Addendum – Resource Recovery Park LVEA

Attention:	Angela Goodwin
Company:	Potentialis
Date:	31 March 2023
From:	Bec Ramsay, Landscape Architect, Boffa Miskell
Message Ref:	Te Rangihaeata, Resource Recovery Park – Addendum to LVEA
Project No:	BM210903

A landscape and visual assessment report (LVEA) was prepared to support an application for a Resource Recovery Park resource consent in December 2022. Since issuing the report, the project team have reviewed the building detail, landscape treatment and the potential for planting to screen the proposed development. Landscape plans have been amended to include an improved alignment for the Hutt River Trail and to provide vehicle access to the river corridor for GWRC to undertake river management activities. Visual effects have been reassessed and the LVEA is amended as follows.

BM210903_600

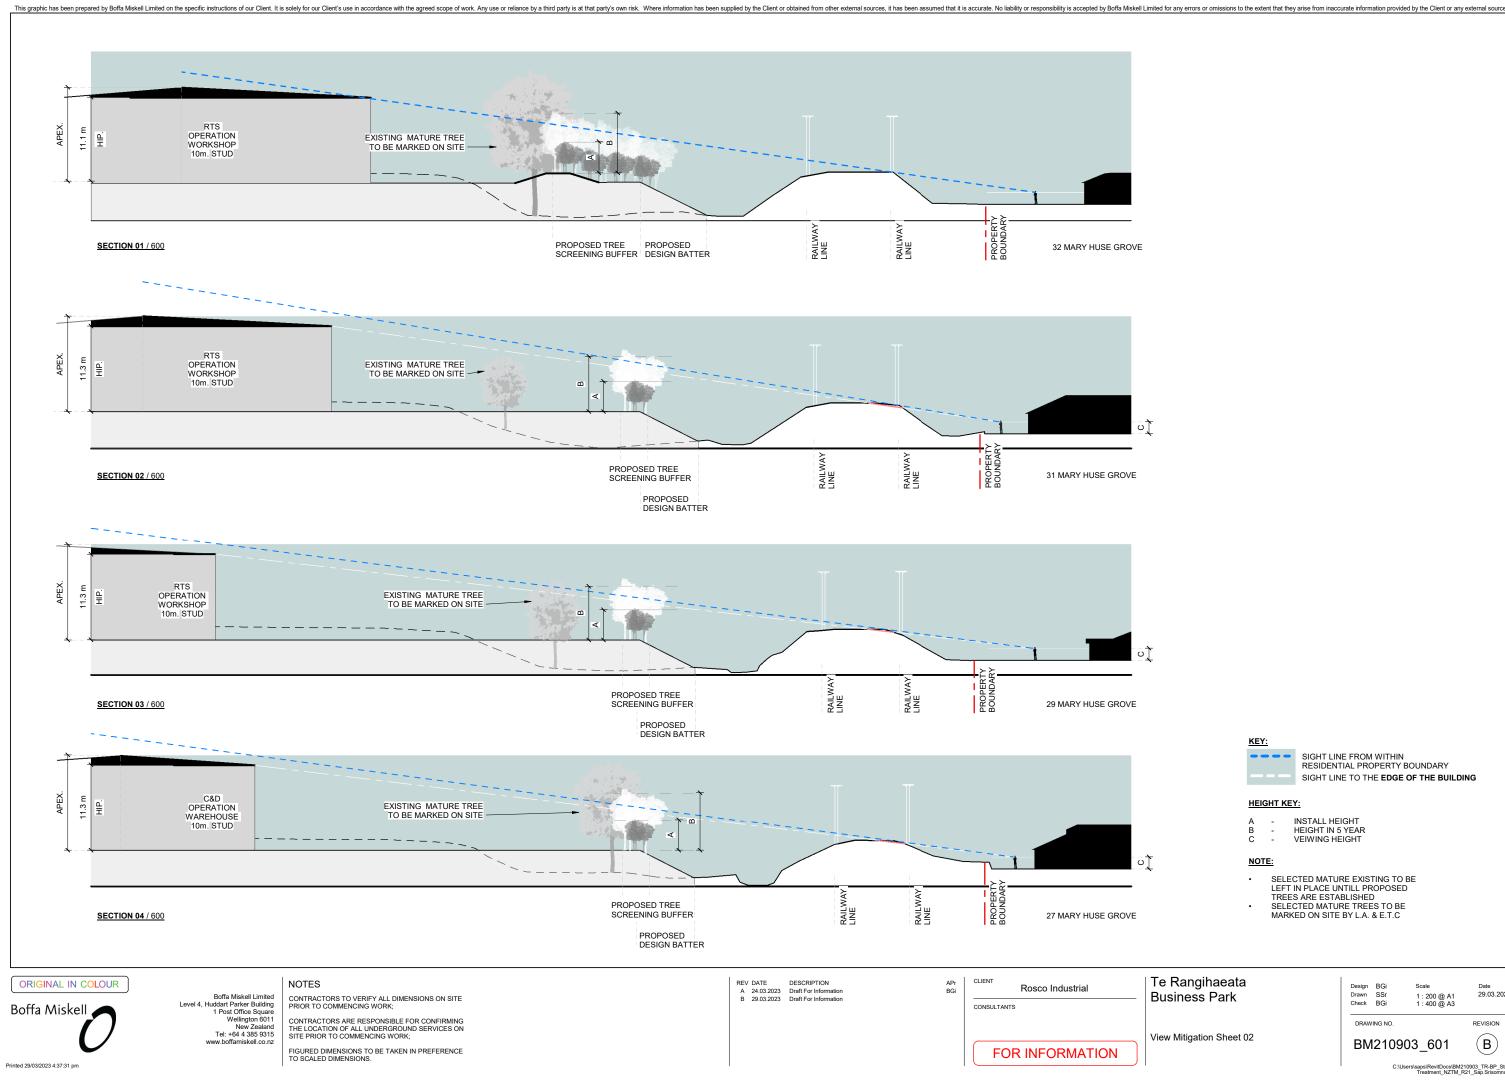
Proposed landscape treatment has been carefully designed (refer Drawing 600 and 601) to include tall species planted at 2-3m height at the top of the site batter slope and across a small bund to provide faster immediate screening. Retention of some existing vegetation with removal as new planting matures will also screen views to the site. As illustrated in the landscape sections (refer Drawing 601), there is no view to the site or proposed buildings from the back yards of number 27, 29 and 31 due to the proximity to and height of the railway embankment. There will be **no visual effect** from these properties.

BM210903_602

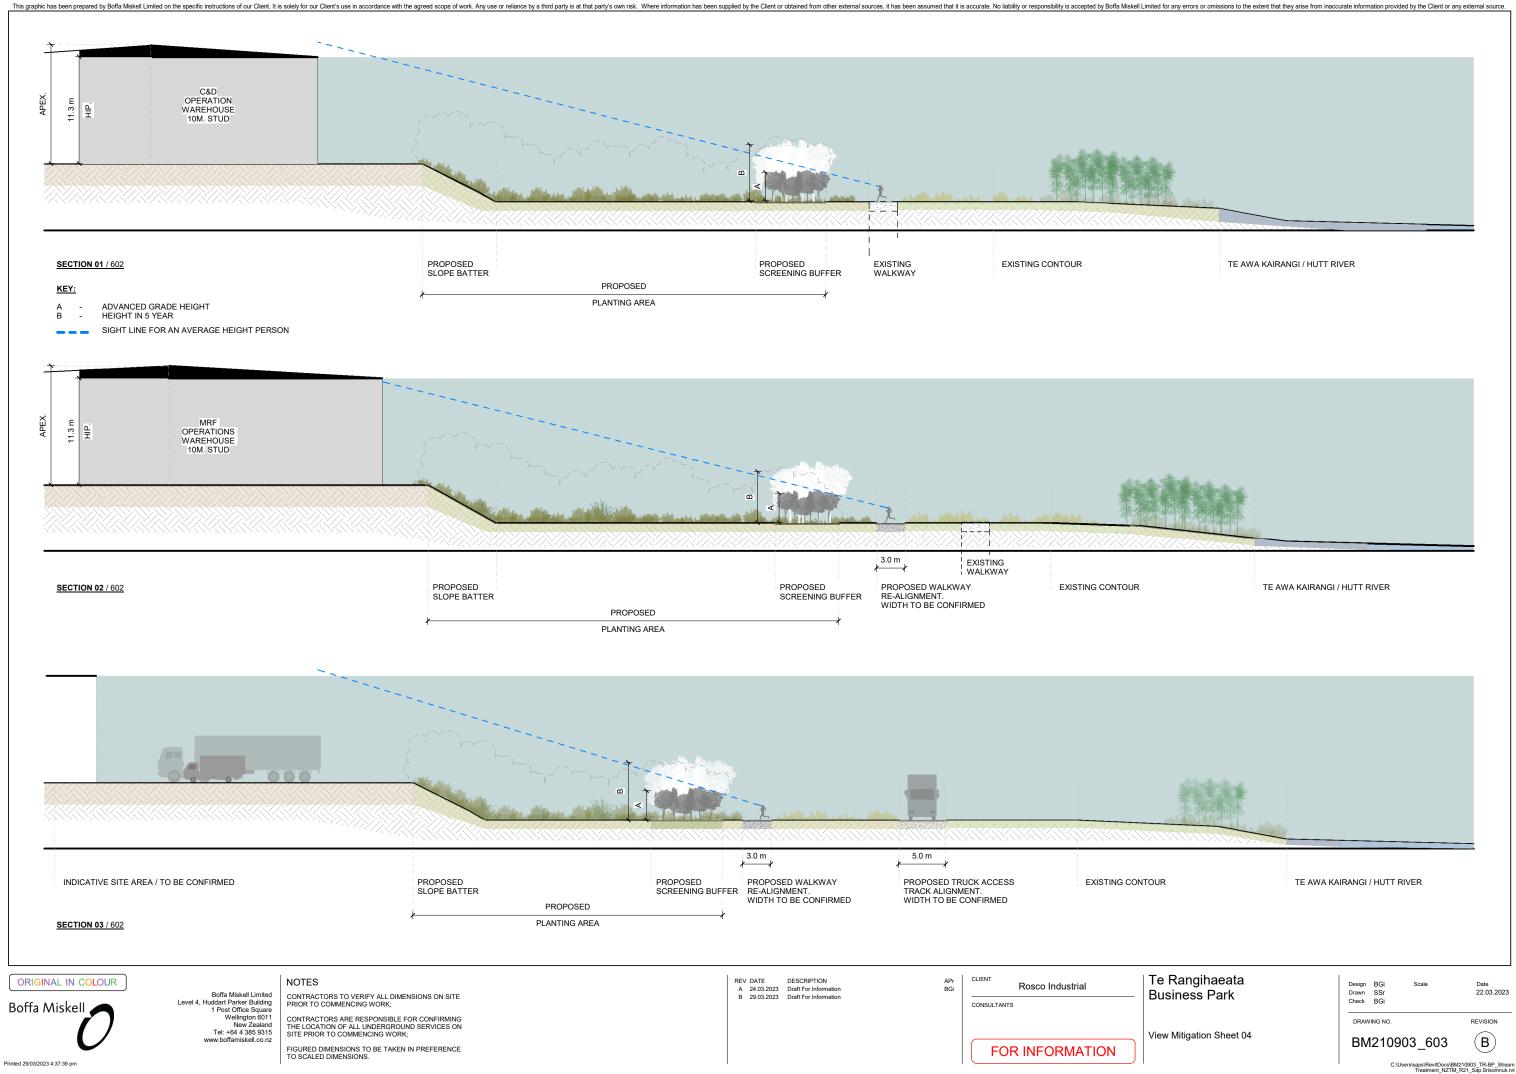
Drawing 603 in the new landscape plan package dated 29/3/23 illustrates the ability of proposed planting to screen the proposed buildings entirely as seen from the adjacent trail after 5 years of planting establishment. In the interim period, partial views of the dark green coloured buildings will be visible intermittently through and above the proposed vegetation. Refer to visual simulations 5-8.
